JOI-TEC-060

GENUINE SPICER® LIGHT DUTY U-JOINTS WITH VARYING THICKNESS COLOR CODED SNAP RINGS

DATE: September 9, 2011

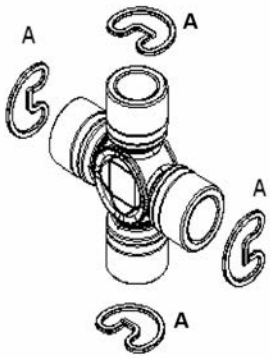
The following Genuine Spicer® light duty u-joints are now being supplied with additional snap rings with different thicknesses. These multiple thickness snap rings (color coded for easy identification) are provided to ensure the proper tolerance fit in various Spicer® driveline components. The U-Joint Part Numbers affected are as follows:

The copper snap rings are most commonly used (typically the thinnest snap ring in the kit). However in select situations, the thicker snap rings will be required for proper tolerance fit and installation. Follow proper installation instructions when installing snap rings, and always use the same thickness/color snap ring on the opposing bearing cap.

"A" Location should be the same thickness/color

"B" Location should be the same thickness/color

"A" Location should be the same thickness/color
